Company: San Diego Gas & Electric Company (U 902 M)
Proceeding: 2024 General Rate Case – Track 3
Application No.: A.22-05-016
Exhibit: SDG&E-T3-WMPMA-16

**Appendix A
SED Incident Investigation Report for 2018 Camp Fire with Attachments**

Incident Investigation Report

Incident Number: E20181108-01

Figure 1: Chart of SCADA data recorded at Circuit Breaker 152 on the Caribou-Palermo 115 kV Transmission Line just before the incident.⁷⁷

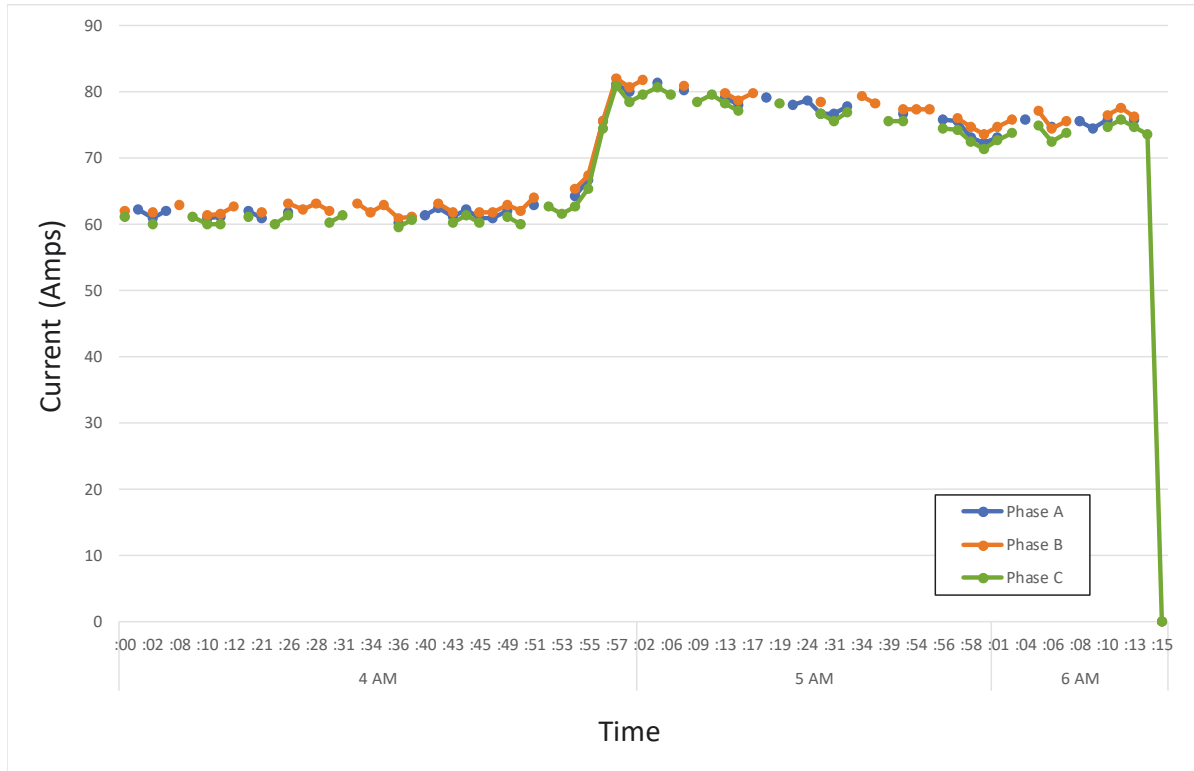
- At approximately 0457 hours on November 8, 2018, the Supervisory Control and Data Acquisition (SCADA) data from the Palermo Substation¹⁵ showed the current in the line reached approximately 80 Amps¹⁶ as shown in Figure 1.

Figure 8. Typical location of runner arms on transmission towers similar to the Incident Tower. This is PG&E Tower :20/160 of the Caribou-Palermo 115 kV Transmission Line.⁸⁴

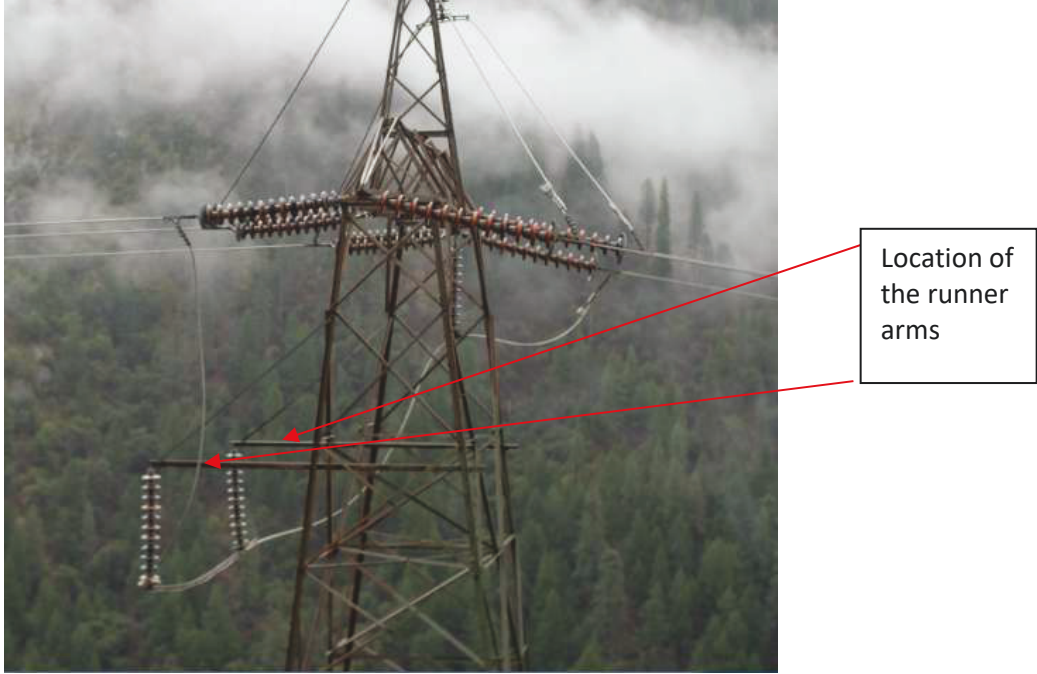
elongated holes in Figure 6 and Figure 7. For reference, Figure 8 shows a typical location of runner arms on transmission towers that have them.
